SUBDIVISION REPORT - CONCEPT/DEVELOPMENT PLAN

► FILE #:	1-SF-23-C	AGENDA ITEM #:	29
	1-E-23-DP	AGENDA DATE:	3/9/2023
POSTPONEMENT(S):	1/12/2023, 2/9/2023		
► SUBDIVISION:	BEELER ROAD SUBDIVISION		
► APPLICANT/DEVELOPER:	MESANA INVESTMENTS - BEELER ROAD		
OWNER(S):	Mesana Investments, LLC		
<hr/>			
TAX IDENTIFICATION:	29 188.03	View map on KGIS	
JURISDICTION:	County Commission District 8		
STREET ADDRESS:	0 BEELER RD		
► LOCATION:	East and west side of Beeler Rd, south of Beeler Farms Ln		
SECTOR PLAN:	Northeast County		
GROWTH POLICY PLAN:	Planned Growth Area		
WATERSHED:	Beaver Creek		
► APPROXIMATE ACREAGE:	27.539 acres		
<hr/>			
► ZONING:	PR (Planned Residential)		
► EXISTING LAND USE:	Agriculture/Forestry/Vacant Land		
► PROPOSED USE:	Attached and detached residential subdivision		
SURROUNDING LAND USE AND ZONING:	North: Single family residential -- PR (Planned Residential) South: Single family residential, rural residential, agriculture/forestry/vacant -- A (Agricultural) East: Agriculture/forestry/vacant -- PR (Planned Residential) West: Agriculture/forestry/vacant, rural residential, single family residential -- PR (Planned Residential), A (Agricultural)

**1-SF-23-C / 1-

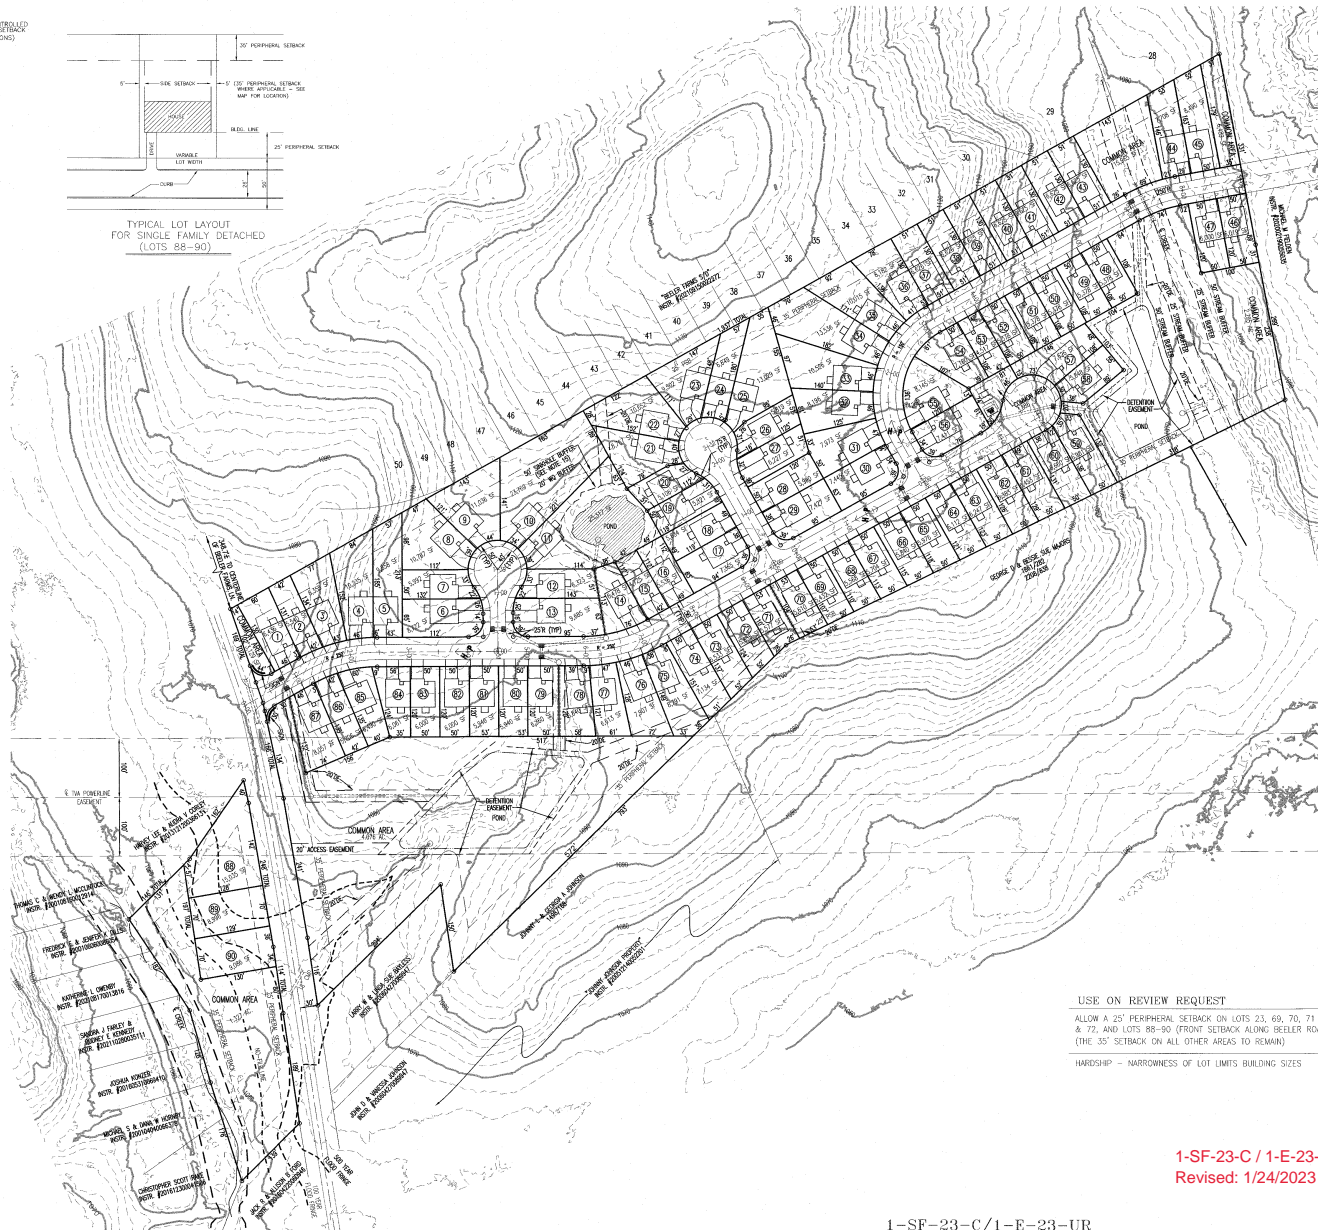
1. Reduce the minimum vertical curve on Road 'A' from K=25 to K=15 at STA 0+75

1. Reduce the minimum horizontal curve radius from 250' to 150' at STA 2+25 on Road 'D'

1. Increase the maximum intersection grade from 1% to 3% on Road 'A' at Beeler Road
2. Increase the maximum intersection grade from 1% to 3% on Road 'B' at Road 'A'
3. Increase the maximum intersection grade from 1% to 2% on Road 'C' at Road 'A'
4. Increase the maximum intersection grade from 1% to 3% on Road 'D' at Road 'A'

KNOX COUNTY ENGINEERING AND PUBLIC WORKS RECOMMENDATION:

Approve.
  1/3/23

* The maximum intersection grade is 2% when there is a pedestrian crosswalk.
